To: Acacia Hasler, Raymond Cheng and Simi Shah
transportconsultations@camden.gov.uk

Consultation on improvements in Prince of Wales Road

At the Haverstock Hill junction (sheet 1 of the design drawing):

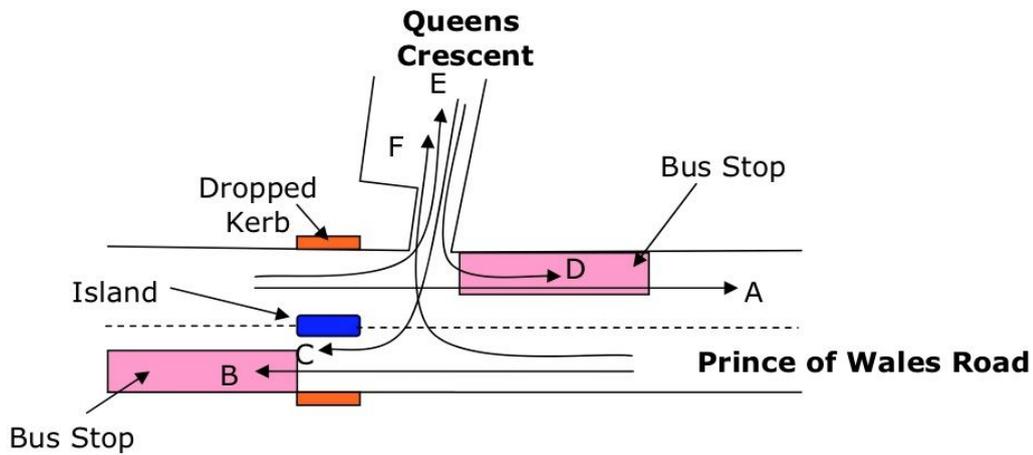
But we are disappointed to see the following proposals for advisory cycle lanes:

Southbound cycle lane on Haverstock Hill down to the bus lane.
